## Grid Code Modification Proposal Form

# GC0155: Clarification of Fault Ride Through Technical Requirements

**Overview:** An alternative to GC0151 which addressed the Fault Ride Through (FRT) compliance process and proposed minor improvements to the FRT technical requirements. This alternative was insufficiently scrutinised as part of the GC0151 urgent modification process hence Ofgem, while rejecting it in their decision letter dated 8 November 2021, noted that it had merit and should be brought forward subsequently.

Figure 1 showing theoretical worst case fault which plant must be capable of riding through

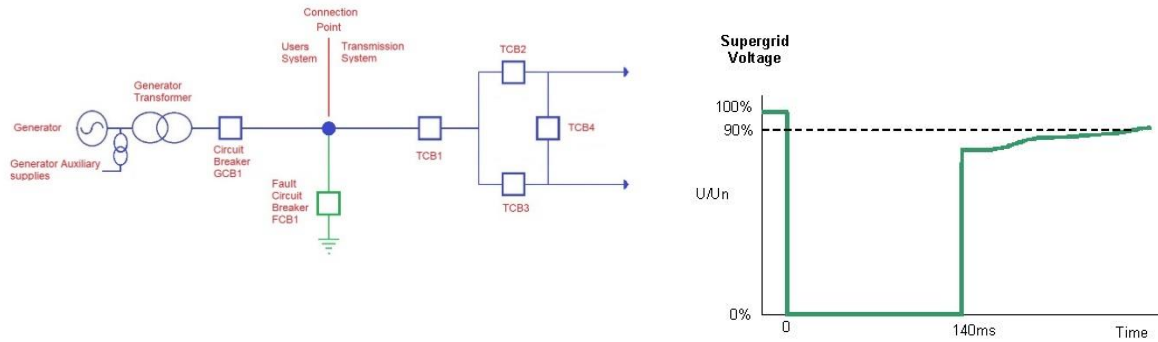
The new section CC.6.3.15(a)(i)(a) will only deal with plant capabilities by clarifying that the plant has to be capable of riding through the worst fault that the network could impose which is a 3-phase short circuit at the connection point which lasts for up to 140ms as shown in figure 1 below. To achieve this, the words “be design to” will be added to section CC.6.3.15(a)(i)(a) as can be seen in the legal text in appendix 1.

Figure 2 showing a fault which can be cleared by transmission system breakers TCB3 & 4

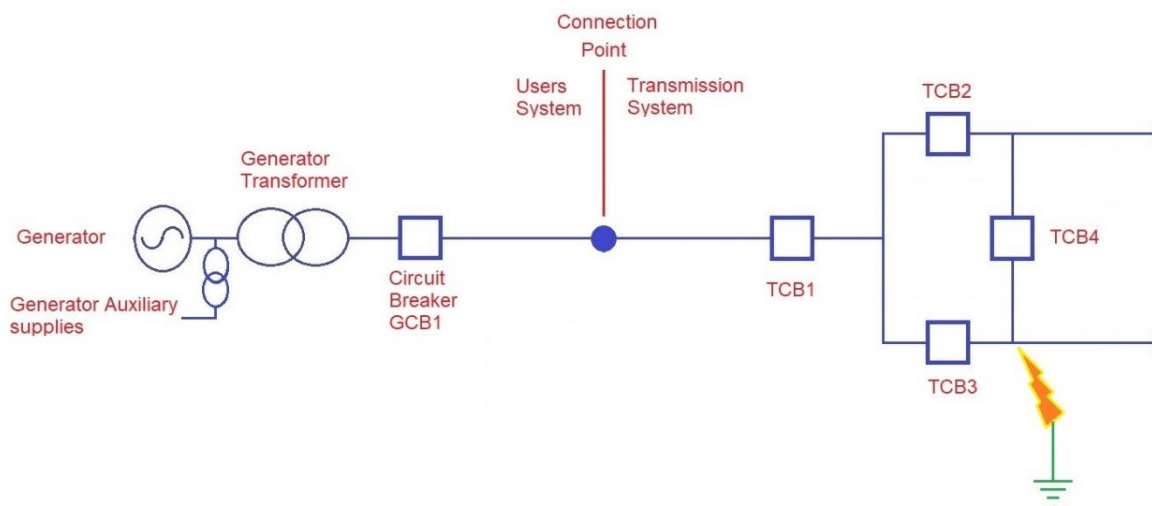
The new section CC.6.3.15(a)(i)(b) will specify the actions to be taken if a fault occurs by requiring that plants ride through faults in the transmission system which can be cleared by the transmission system circuit breaker as shown in figure 2 below and by adding the following text as the introduction to the section

- (b) Each **Generating Unit, DC Converter, or Power Park Module** and any constituent **Power Park Unit** thereof and **OTSDUW Plant and Apparatus** shall remain transiently stable and connected to the **System** without tripping of any **Generating Unit, DC Converter or Power Park Module** and / or any constituent **Power Park Unit, OTSDUW Plant and Apparatus**, and for **Plant and Apparatus** installed on or after 1 December 2017, reactive compensation equipment, for any balanced and unbalanced fault where subjected to a voltage dip at either the **Onshore Grid Entry Point or Interface Point** as applicable where the voltage remains either on or within the envelope shown in figure CC.6.3.15(a)(i)(a) except where:

Figure 3 showing a fault which can only be cleared by generator breakers GCB1

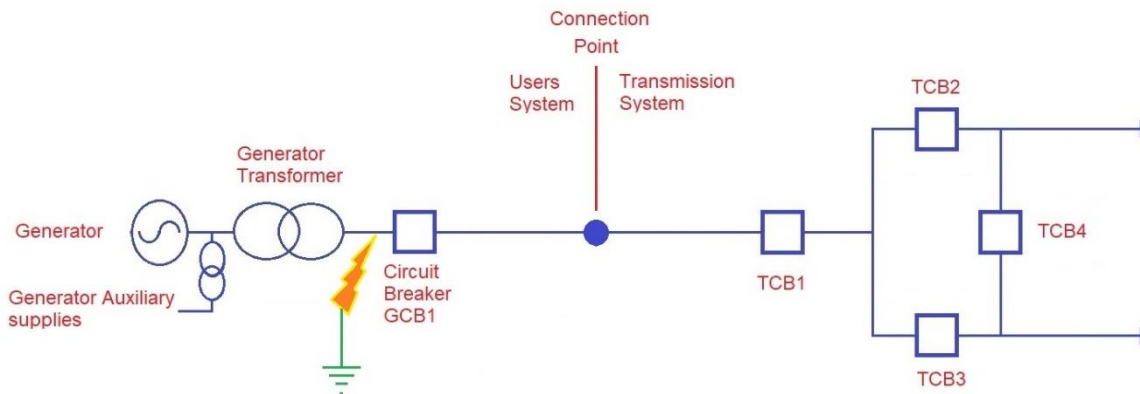
Firstly if the fault is on the Generator's equipment then the Generator shall be required to trip to clear the fault from the transmission system as detailed in the proposed new section CC.6.3.15(a)(ii)(b)(i) (note that this is already permitted in the ECCs), as follows:-

**Power Park Module** and any constituent **Power Park Unit** thereof and **OTSDUW Plant and Apparatus** shall trip to clear the fault from the **Transmission System**. The protection schemes and settings should not jeopardise **Fault Ride Through** performance as specified in CC.6.3.15.1

Figure 4 showing a fault which can only be cleared by generator breaker GCB1 & transmission circuit breaker TCB1

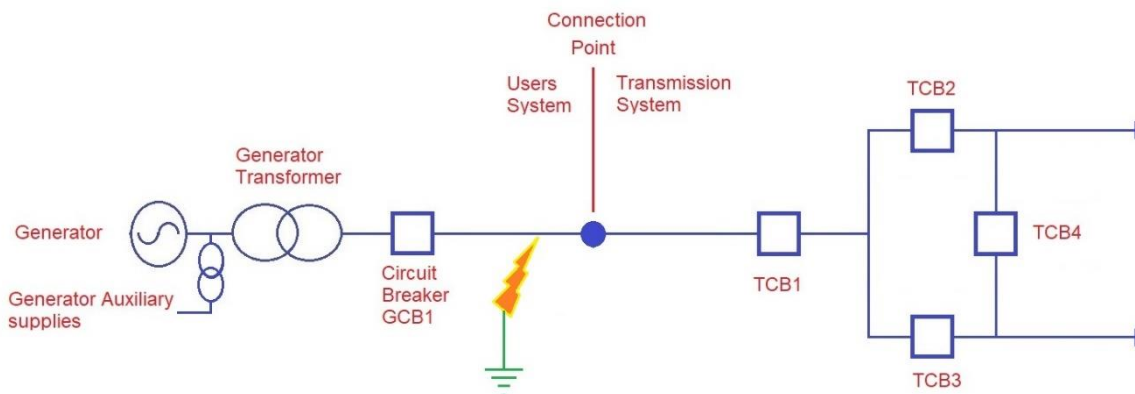
Secondly if the location of the fault on the network that means that the fault can only be cleared by operation of both Transmission and the Generator circuit breaker as shown in figure 4, again the Generator will be permitted to trip to clear the fault as detailed in the proposed new section CC.6.3.15(a)(i)(b)(ii) and ECC.6.3.15.8(vi)(i), as follows:-

the location of the fault means it cannot be fully cleared without tripping the of **Generating Unit, DC Converter, or Power Park Module** and any constituent **Power Park Unit** thereof and the **OTSDUW Plant** shall trip as required.

Figure 5 showing a fault which can be cleared by transmission breakers TCB1,2&3, however this results in the Generator being islanded from the main transmission system and needs to come off

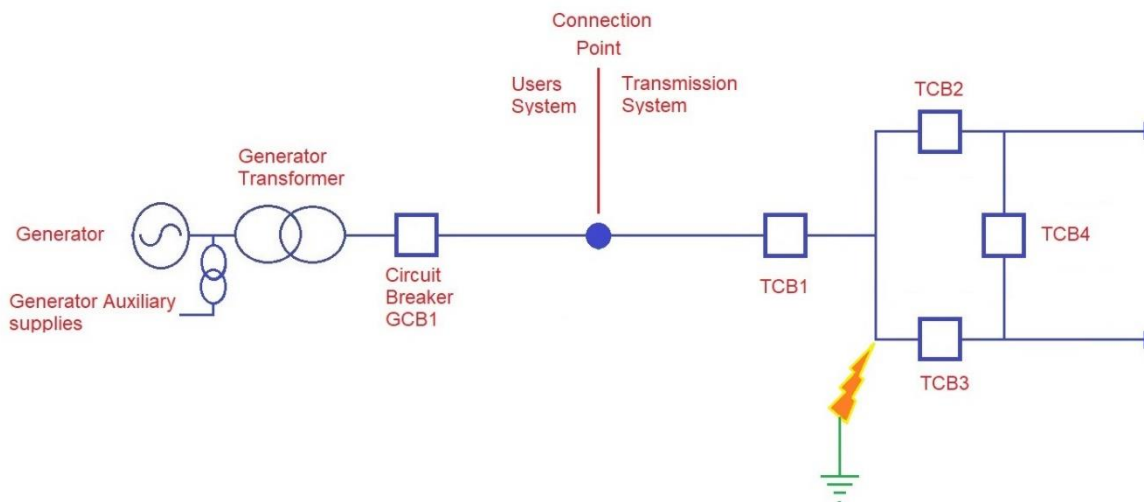
Thirdly, if the location of the fault on the network means that the Generator will become islanded by the operation of the transmission circuit breakers as shown in figure 5 then it shall be permitted to trip as detailed in the proposed new sections CC.6.3.15(a)(ii)(b)(iii) and ECC.6.3.15.8(vi)(ii), as follows:-

clearance of the fault results in the **Generating Unit, DC Converter, or Power Park Module or OTSDUW Plant** becoming islanded and disconnected from the **Total System** and not supplying **Customers** (where CC.6.3.7(c)(i) applies), then the **Generating Unit, DC Converter, or OTSDUW Plants** shall be permitted to trip as required.

Figure 7 showing the proposed reactive current injection requirements, requiring the current to always remain above the black line

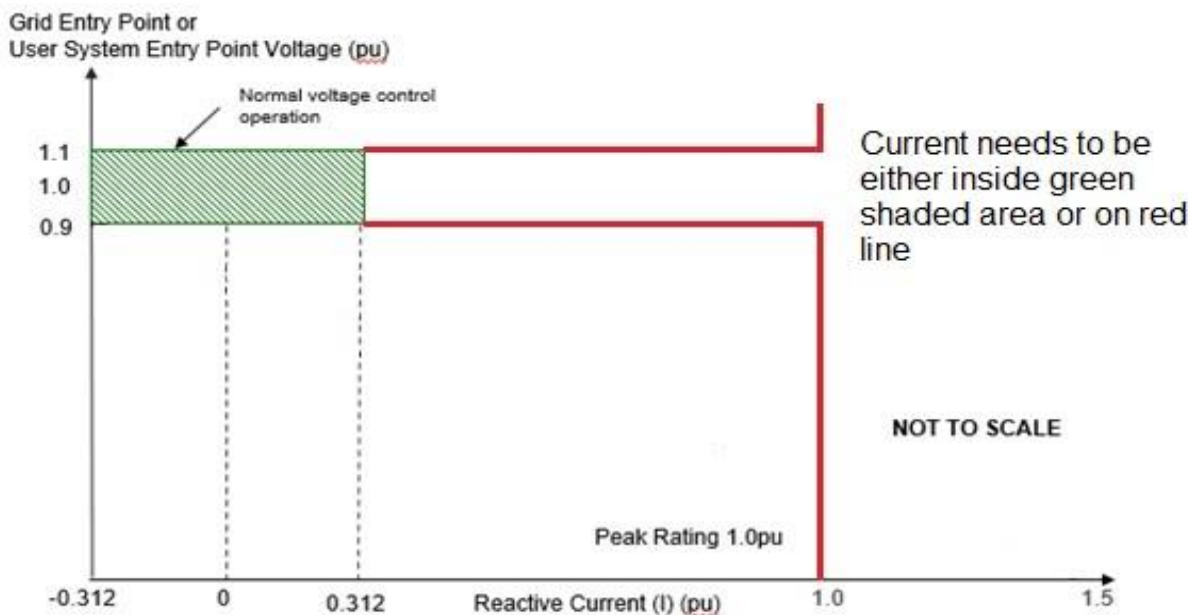
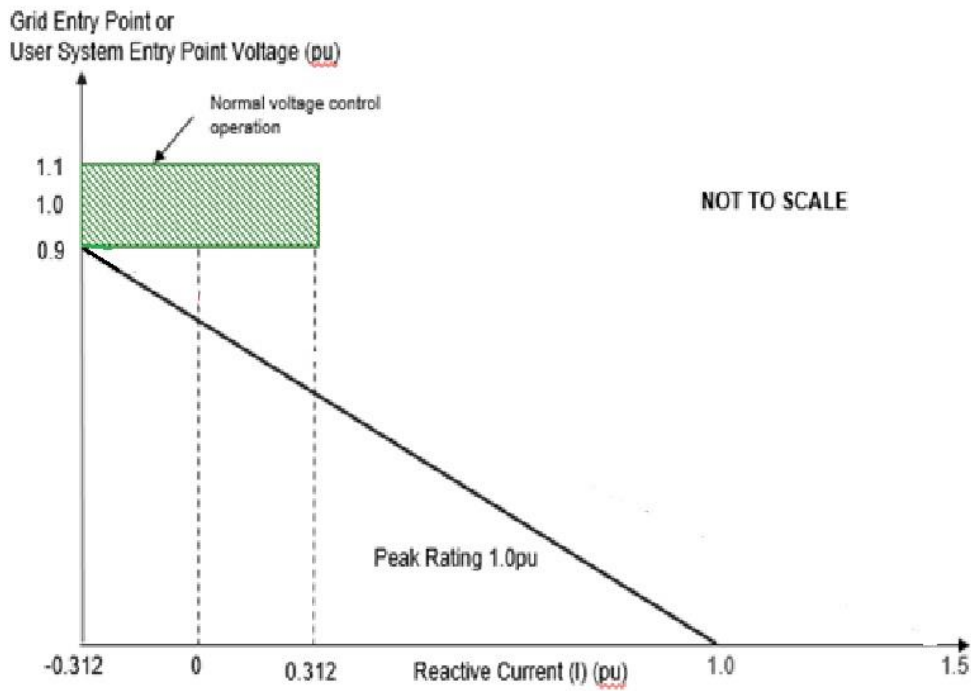
The area of the current legal text which technically creates the biggest problem in relation to compliance are in sections CC.6.3.15 (a)(ii) and ECC.6.3.15.9.2.1(a)(i) which currently state "for which the voltage at the Grid Entry Point (or Interface Point in the case of OTSDUW Plant and Apparatus) is outside the limits specified in CC.6.1.4, each Generating Unit or Power Park Module or OTSDUW Plant and Apparatus shall generate maximum reactive current". If this requirement is drawn out on the figure 6 below where the current and voltage must always either be within the green shaded area or on the red line.

The reason this creates compliance issues is: as drafted, very few plants (if any) actually do this and it has presumably drifted in as a drafting oversight relating to PPM requirements. This issue has previously been identified in the workgroup GC0111 on Fast Fault Current injection and in the GC0137 VSM workgroup and has been fixed for new PPMs, however currently all synchronous Generator and older PPM will technically be non-compliant with this FRT requirement as drafted. This issue was dealt with in GC0111 by adding a new Figure ECC.6.3.16(a), however this is more onerous than is required for GB Users so the graph shown in figure 7 is proposed with text changes as follows:-

- (iv) During the period of the fault as detailed in CC.6.3.15.1 (a) (i) for which the voltage at the **Grid Entry Point** (or **Interface Point** in the case of **OTSDUW Plant and Apparatus**) is outside the limits specified in CC.6.1.4, each **Generating Unit** or **Power Park Module** or **OTSDUW Plant and Apparatus** shall inject a reactive current above the heavy black line shown in Figure CC.6.3.15(b) without exceeding the transient rating limit of the **Generating Unit, OTSDUW Plant and Apparatus** or **Power Park Module** and / or any constituent **Power Park Unit** or reactive compensation equipment.

Figure 8 showing a typical active power response of a unit at low load to a fault

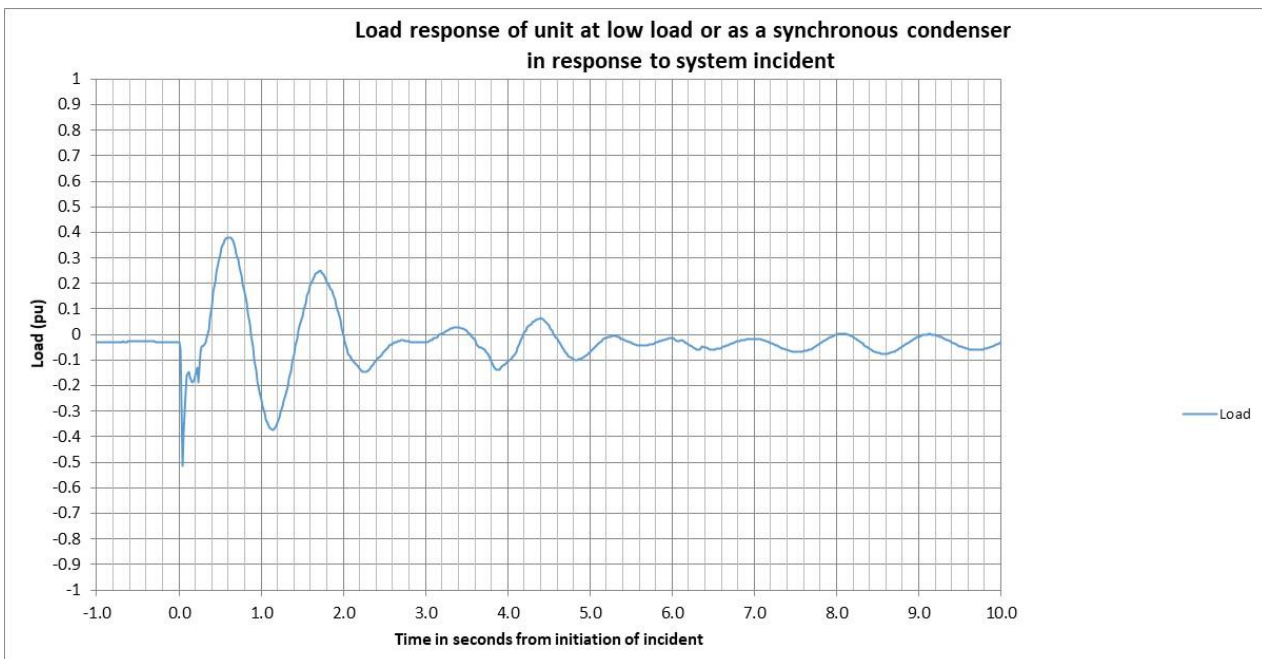
Whilst this works in principle at higher loads, it does create an issue at lower loads if you consider a real event for a unit operating as a synchronous condenser in figure 8.

If you look at the initial load which is 0.02 pu then 90% of this small number you get a very small number, it is also difficult to see how a sensible compliance assessment can be carried out at these levels and it is hence suggested that under these circumstances the tolerance should be changed.
